Outline of Inadequacies of Mr. Lee's Current Application

**MASTER MAP
OUTLINING
CONCERNS
AND
INADEQUACIES
OF MINING
APPLICATION**

RIPARIAN AREAS SURROUNDING MINING SITE

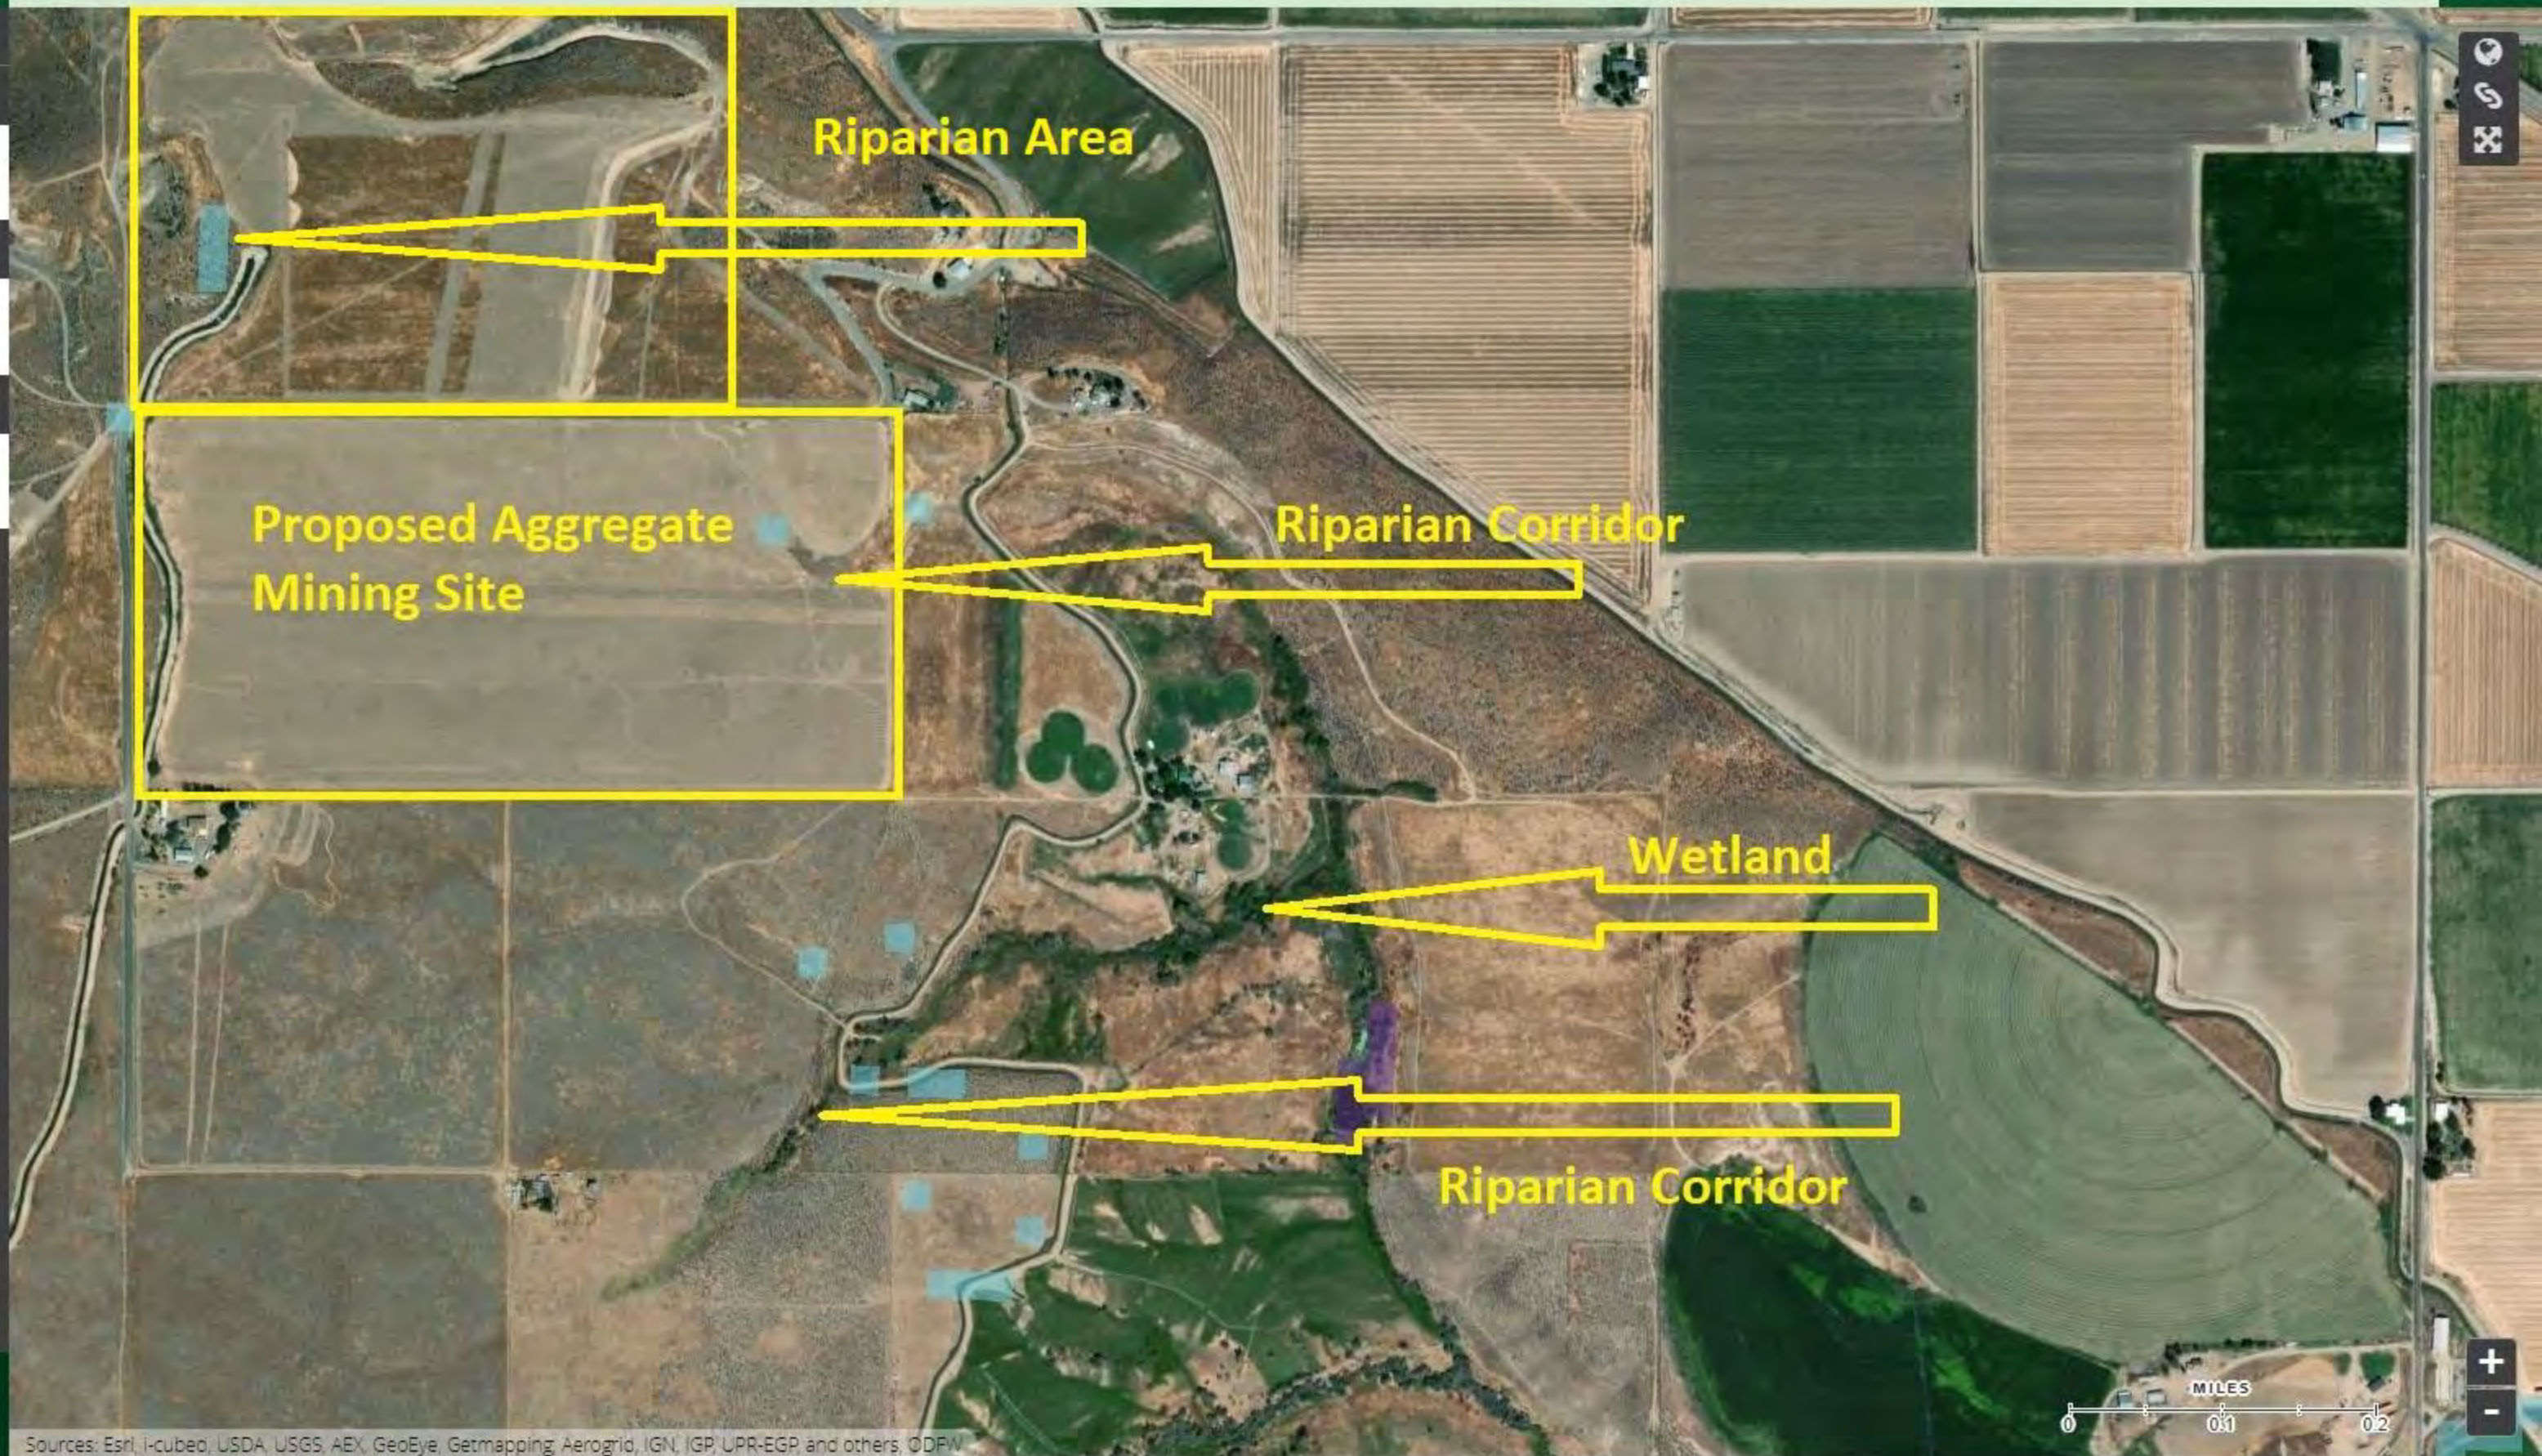
- a. This is documented by several state and federal maps. See maps by Oregon Department of Fish and Wildlife(ODFW), National Wetlands Map, Oregon Water Resources, State wide Wetlands. These maps document a main Riparian Corridor that originates on the proposed mining site specifically Phase #1. This riparian corridor then flows into an underground riverine and onto adjacent properties that contain crucial wetlands which eventually flow directly into the Snake River. There are also several other documented riparian areas to the west of Phase #1 in the proposed mining area known as Phase #3. Phase #3 was significantly disrupted last year when applicant illegally mined the area removing perennial native vegetation and wetland areas. See attached maps and photos.

Head Waters to the Riparian Corridor that drains into Wetland and continues to the Snake River

Riparian Corridor, Riverine, Freshwater Emergent Wetland, Wetland, Freshwater Pond for Irrigation. All Mapped and Recorded on the National Wetlands Inventory

Main Burrow Pit. No Maximum Depth Specified. Test Pits up to 46 Feet Deep.

Pond Proposed in middle of Riparian area

4% Grade Drainage Path to South and East. 100 Foot Drop from West to East side

LDS Irrigation Canal. Dirt Floor. Percolates to the East and South. 4% Grade from West to East. 100 Foot drop from West to East. Slope Stability Concerns

PROPOSED AGGREGATE MINING SITE

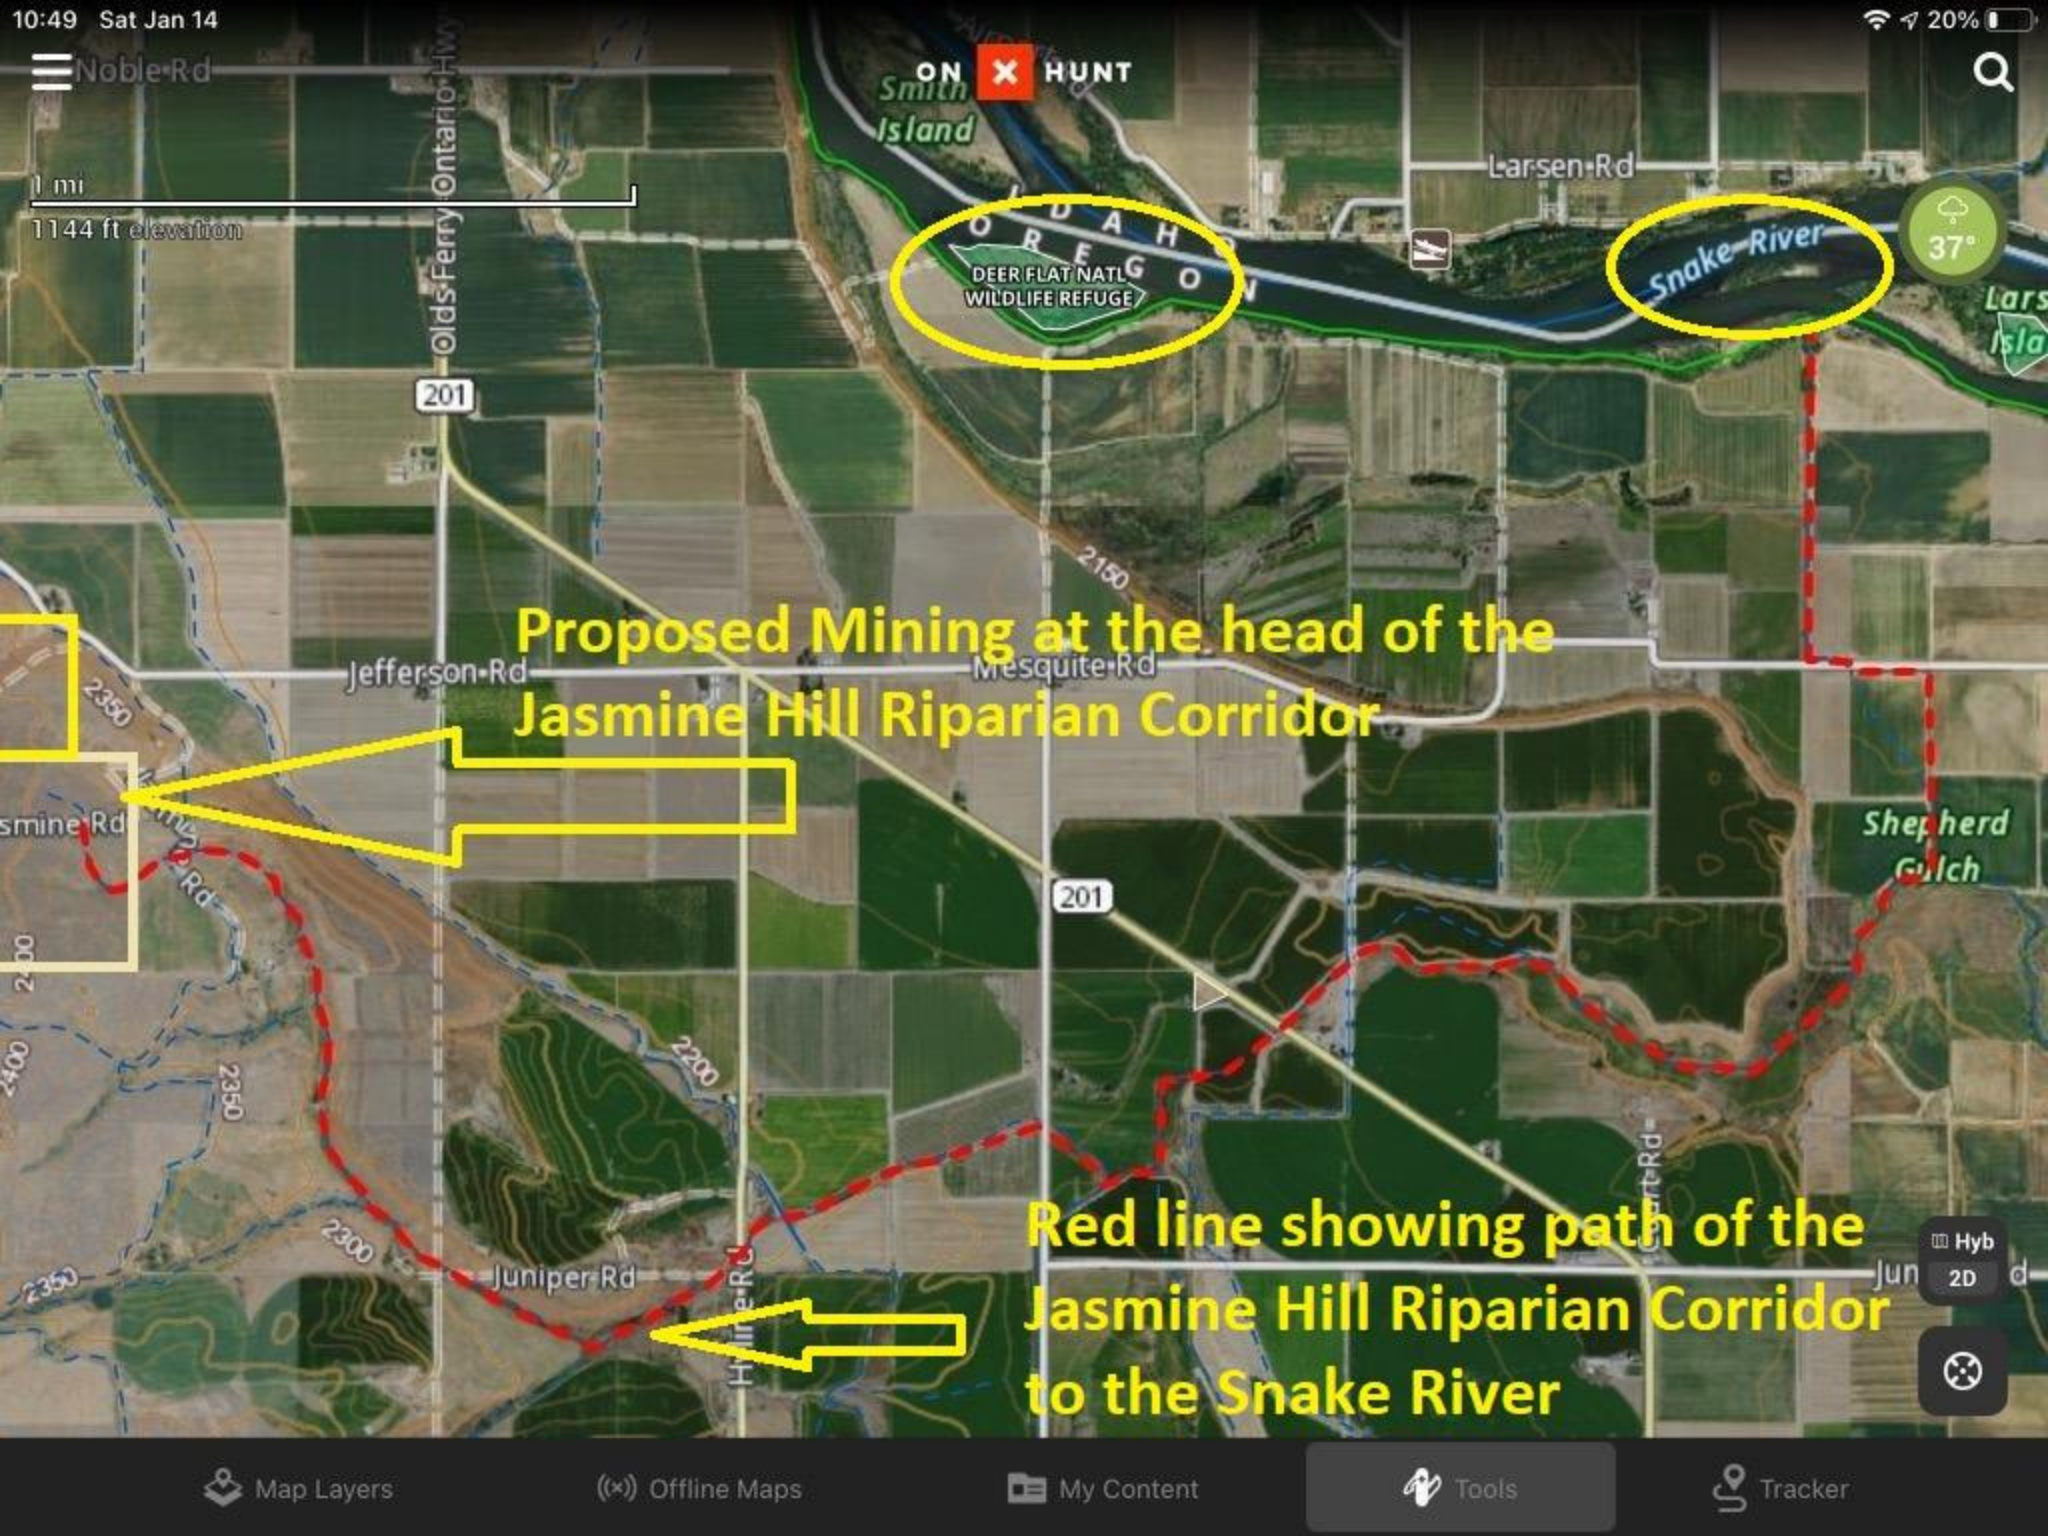
Proposed Mining at the head of the Jasmine Hill Riparian Corridor

Red line showing path of the Jasmine Hill Riparian Corridor to the Snake River

**DRAINAGE OF EARTH
BASED CANAL,
GROUNDWATER, &
RIPARIAN CORRIDORS
WITHIN PROPOSED
MINING AND HOLDING
POND AREA TOWARDS
RESIDENTIAL DRINKING
WELLS, ORGANIC FARM,
WETLAND HABITAT AND
SNAKE RIVER.**

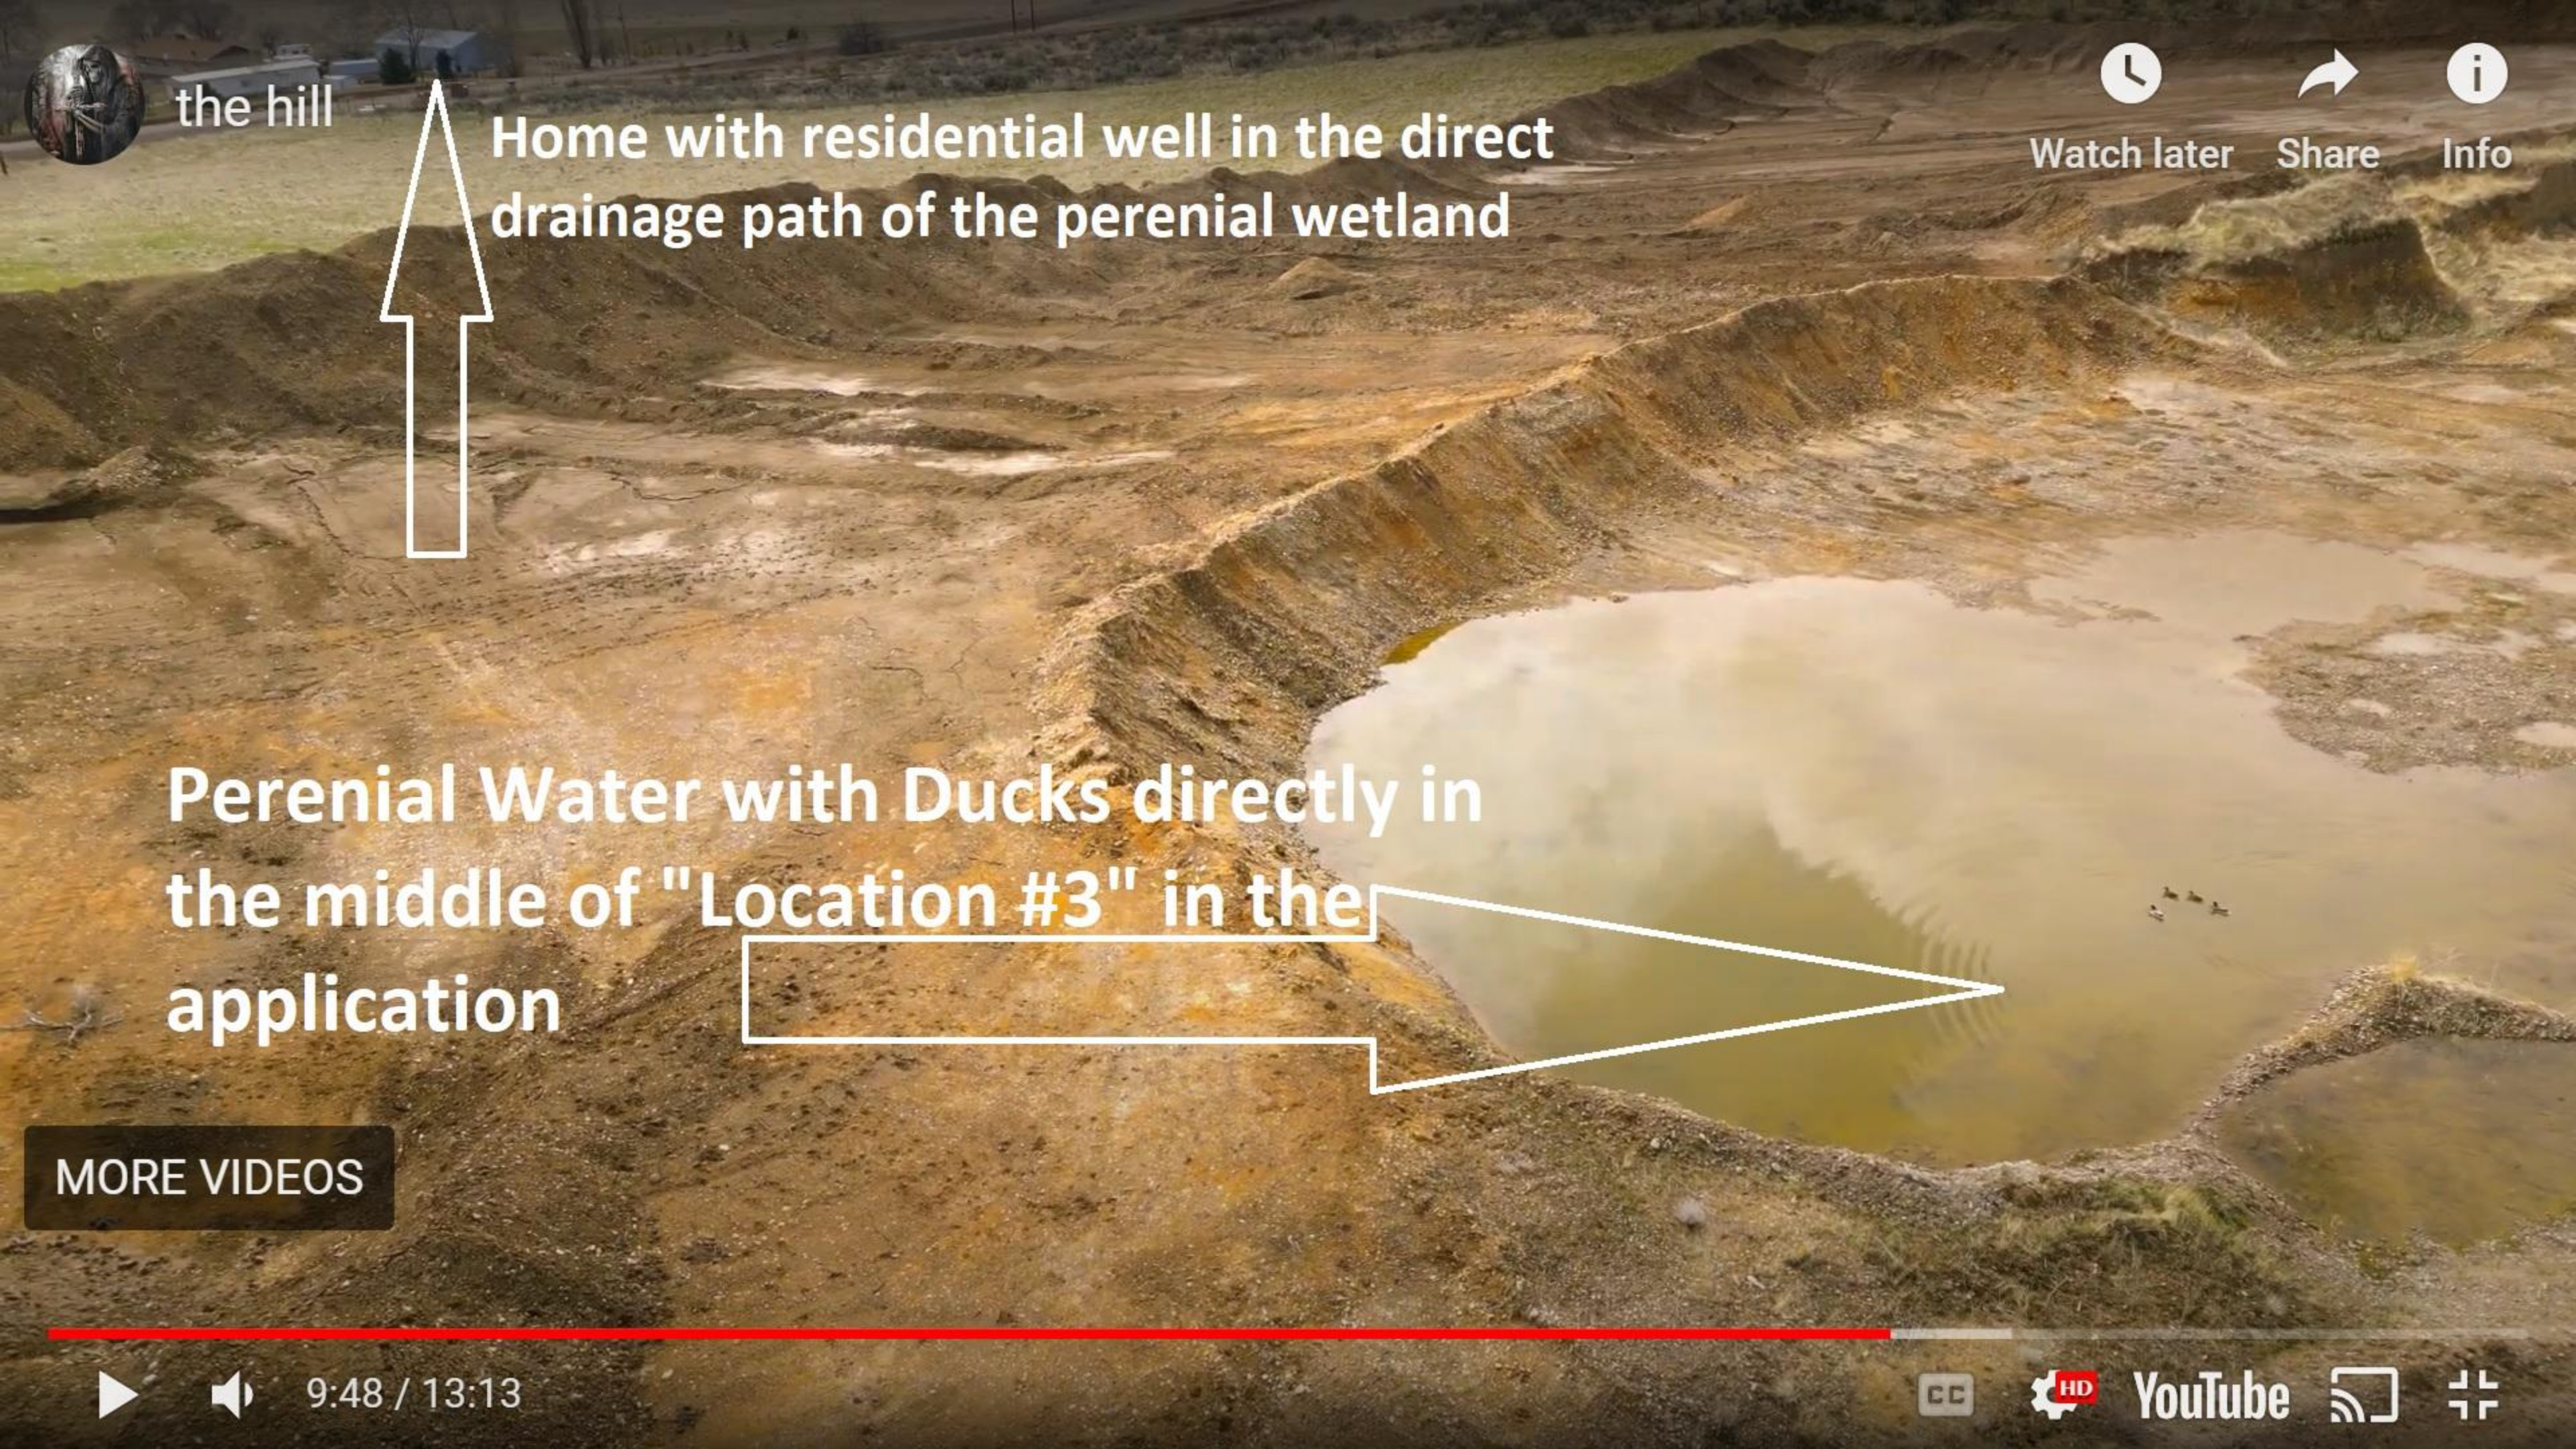
Each home has a residential drinking well in path of water flow

Holding Pond Area described in application

Water flows from Riparian and Large Canal in this direction. 105 feet down / 4% Grade

Water Collecting in test holes Test holes dug illegally

The property in question drops approximately 105 feet from the Western Side to the Eastern side. Ground Water drains from West To East DIRECTLY toward 5 different Homes, EACH with residential wells pulling from the same ground water aquafer. This slope equates to slightly over a 4% grade.

Grad Calculation:
 $2475 - 2370 = 105$ feet
 $105 / 2609.03 * 100 = 4.02\%$

Water percolating from the large canal and existing riparian areas will flow in this direction. Pollutants will come in contact with water and water will contaminate drinking wells.
